## **Board of Architectural Review**

DATE: June 25, 2015  
TO: Board of Architectural Review Chair and Members  
THROUGH: Jason Sutphin, Community Development Division Chief *JDS*  
FROM: Kelly O'Brien, AICP, BAR Liaison *KO*  
SUBJECT: **10579 Fairfax Boulevard – AABEE (formerly Cooking and Company)**

| 3. Request:     | Modifications to building facade and site improvements |

Materials:  
Pressure treated lumber for studs and pannels  
Stucco matching restaurant's wall

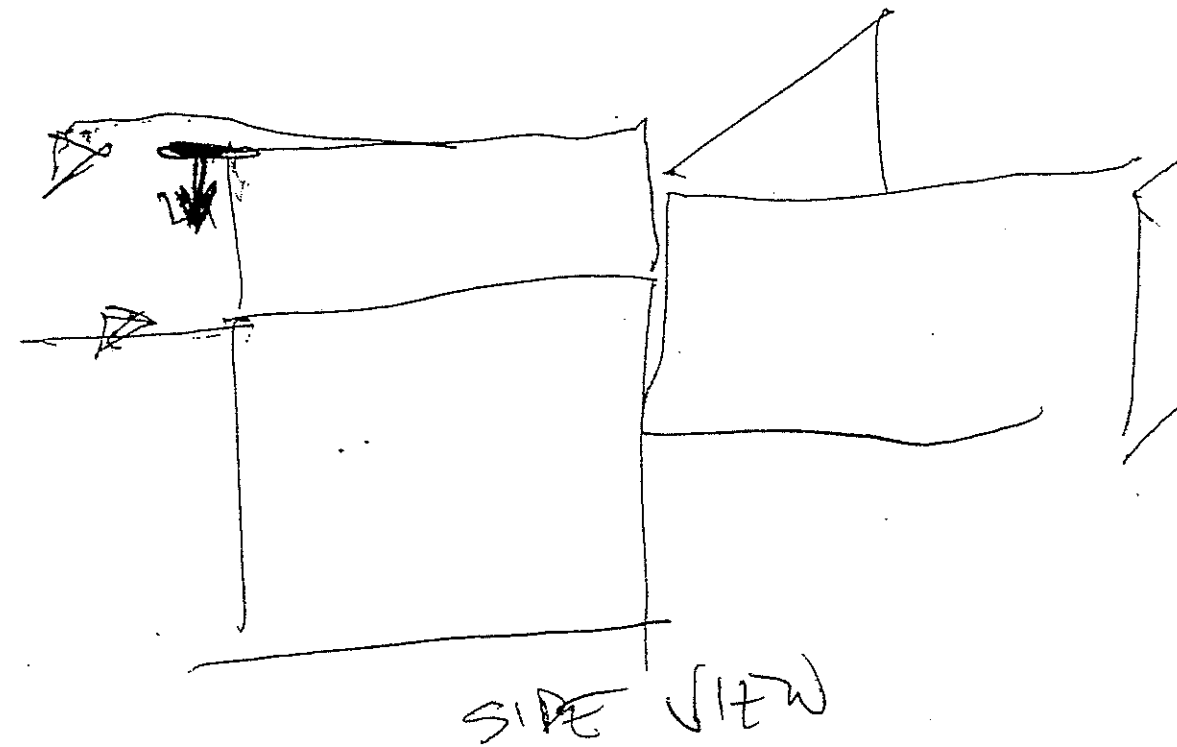
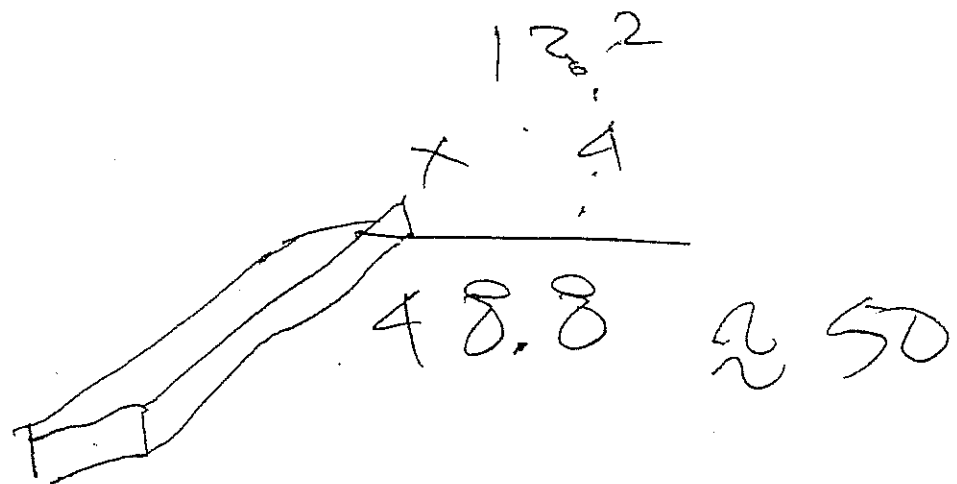
The applicant's proposal calls for Behr 330A-2 "Frosted Lemon" on the building with Behr P440-7 "Mermaid" green roof and trim and bright blue awnings. It appears from the rendering that the gutters are not proposed to be painted however at the site visit it appeared they had been painted red to match the new roof color. The proposed rendering and construction documents show a 5' high parapet built on top of the existing flat roof of the front foyer. The applicant has stated the intent to cap the parapet extension with a premade crosshead pilaster. The parapet is proposed to be finished with stucco.

Staff has no concerns with the building colors other than the roof. Although green roofs have been approved in other locations in the City, it has been for small sections of roof rather than for the entire building. Also the color proposed is bright and staff does not believe the use of this color in the

proposed manner is supported by the Community Appearance Plan. Staff's recommendation is that the roof be painted back to the "Copper Canyon" color that was previously approved by the BAR and is more harmonious with the surroundings as it is near residential properties.

The applicant proposes to replace the "Golfing Green" awnings with bright blue awnings. The application makes no mention of the east or south facades or the patio. Staff recommends the color treatment be continued around the building. Staff also recommends the awnings be painted to match the roof except for the gutters around the parapet which should be painted "Frosted Lemon" to blend them into the building.

2. The roof shall be painted "Copper Canyon" or a similar color to be confirmed with staff prior to painting.
3. The bollards shall be painted "Frosted Lemon" with an accent stripe of "Mermaid" or the same blue used in the awnings.

4. All facades of the building and the patio wall shall be painted "Frosted Lemon".
5. The tents on the patio shall be removed and may be replaced with table umbrellas or other shade structures in blue or "Mermaid" green to be submitted to staff for approval prior to installation.
